FOURSQUARE AT STERLING RANCH PUDSP

LETTER OF INTENT

JUNE 2022, NOVEMBER 2022

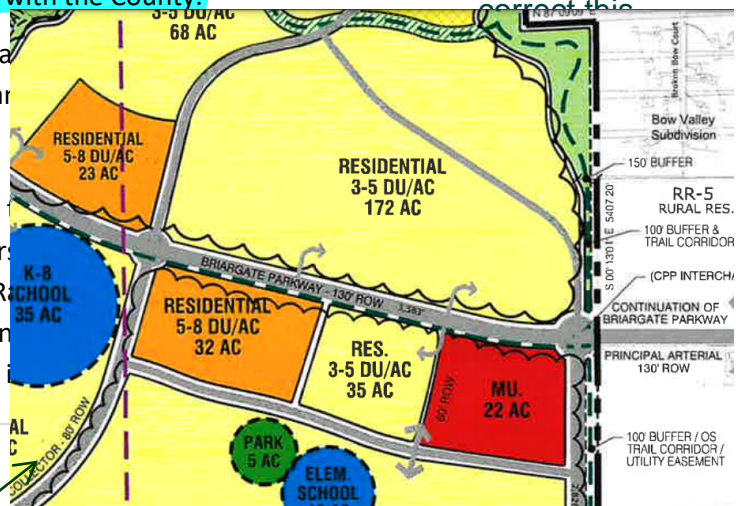
Approved Dec 15
2022 and cap is 4800
